Section 16 Planning Application No. A/KC/507

Annex 1 - Response to Departmental Comments Table

Section 16 Application for Proposed Shop and Services Use at Portion of Godown A on Ground Floor, Block A of Tung Chun Industrial Building, Kwai Chung

Figure 5 : Extract of Assignment Plan

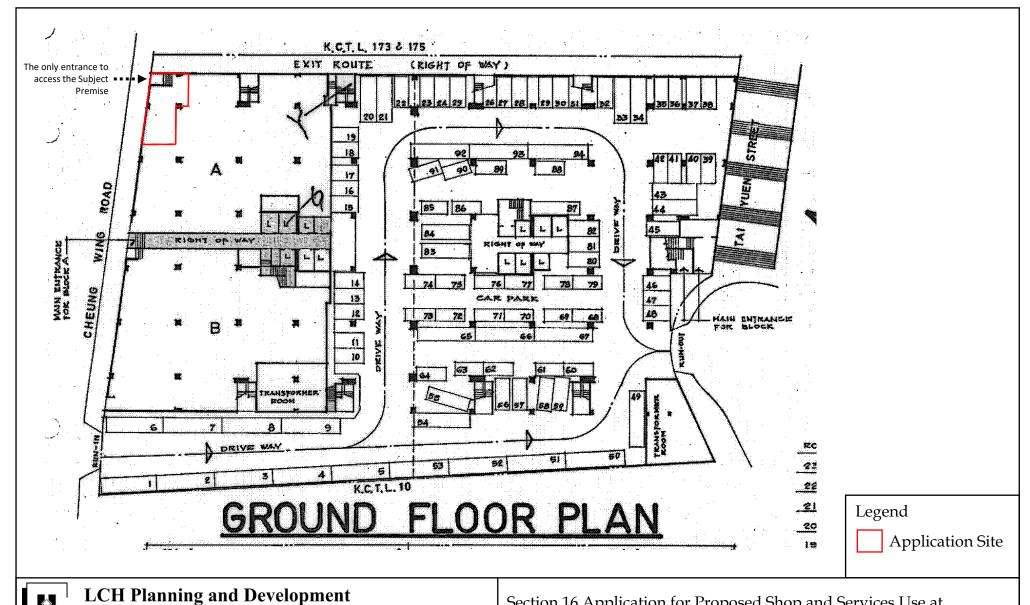
No.	Comments Received	Our Responses			
1. Ca	1. Comments from Tsuen Wan and West Kowloon District Planning Office				
A	Regarding Figure 5 enclosed in the Supplementary Information dated 22.8.2024, it is observed that the Site boundary encroaches onto portion of the exit route (right of way). Please clarify the extent of Site boundary and rectify the figure, as appropriate.	Well noted. Please see attached the revised Figure 5.			
В	Please specify the function of the proposed retail shop under the Recycling Programme operated by The Salvation Army.	Although the Recycling Programme currently occupies portion of 1 st Floor, 2 nd Floor and 3 rd Floor of the same building for storage and warehouse purposes, the function of the proposed retail shop is not necessarily related to the Recycling Programme under this application.
